SERVICE BULLETIN

SB-110416 REV A

DATE ISSUED: 11/4/2016
DATE EFFECTIVE: 11/4/2016
SUPERSEDES NOTICE: None
SUBJECT:
AIRCRAFT AFFECTED: **MODEL:** ICON A5
S/N: 00001, 00003 - 00014
REQUIRED ACTION:
TIME OF COMPLIANCE: Before next flight

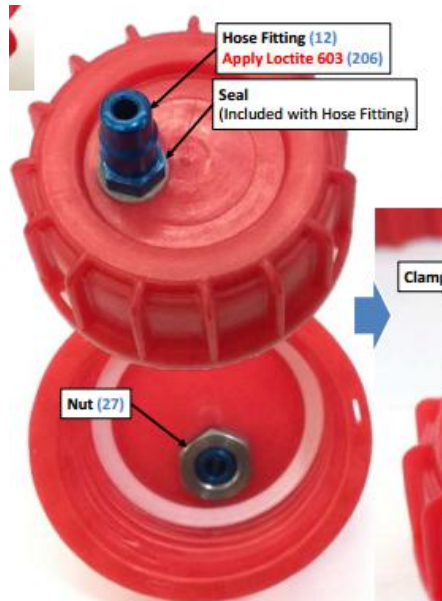
1. Remove engine cowling per ICON maintenance manual chapter 3.4.2.
2. Loosen hose clamp on top of coolant overflow bottle and disconnect hose from coolant bottle.
3. Remove coolant bottle cap.
4. Remove hose fitting (5058K34) from cap.
5. Apply loctite 603 to threads of hose fitting and reinstall into coolant bottle cap.

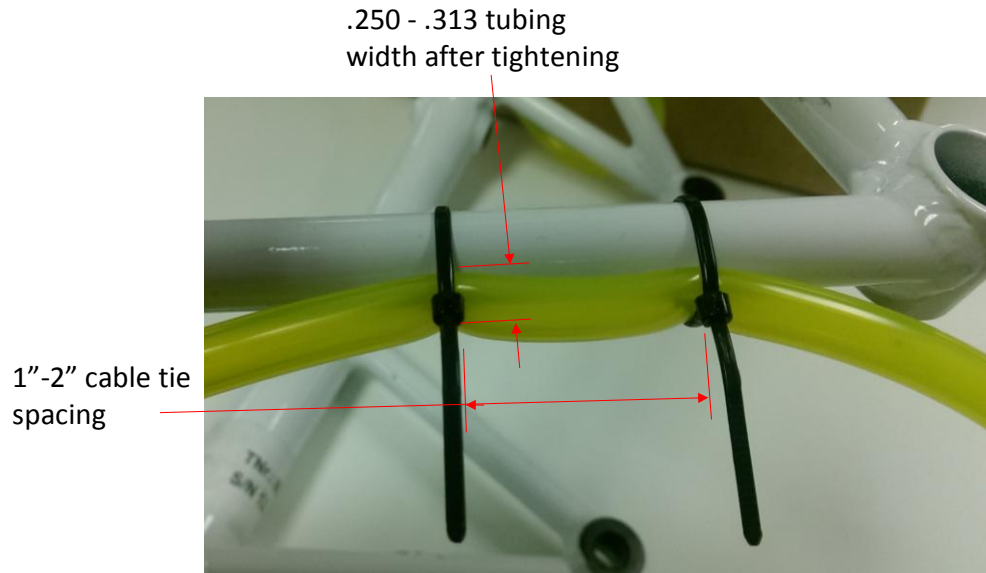
7. Reinstall cap on bottle.
8. Reinstall tubing on hose fitting and secure with hose clamp.
9. Secure tubing to either of the following locations on engine mount using quantity 2 cable ties (TY23MX):

Secure hose to either location
using two cable-ties.
